Title of Change:	Revision of Case Outline 507BA
Effective date:	05 Jul 2024
Contact information:	Contact your local onsemi Sales Office or Sarmila.Kamalanathan@onsemi.com
Type of notification:	This Product Bulletin is for notification purposes only. onsemi will proceed with implementation of this change upon publication of this Product Bulletin.
Change Category:	Assembly Change
Change Sub-Category(s):	Datasheet/Product Doc change

**MECHANICAL CASE OUTLINE
PACKAGE DIMENSIONS**

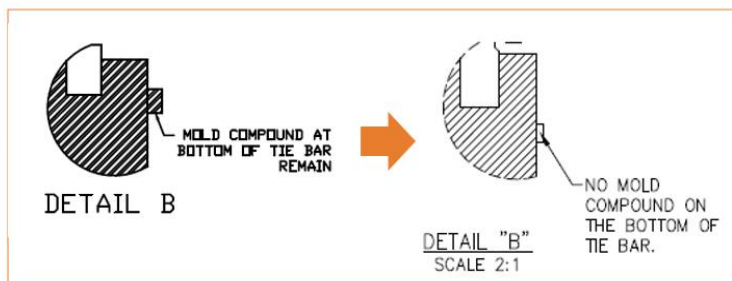
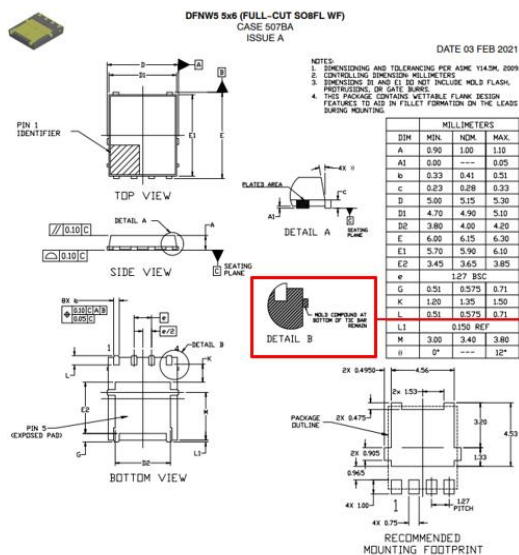
This Product Bulletin is to advise customers of a change to detail B in case outline from “Mold compound at the bottom of tie bar remains” to “No mold compound at the bottom of the tie bar” for case 507BA. No change to solder footprint is required. There is no material, dimension or manufacturing change.
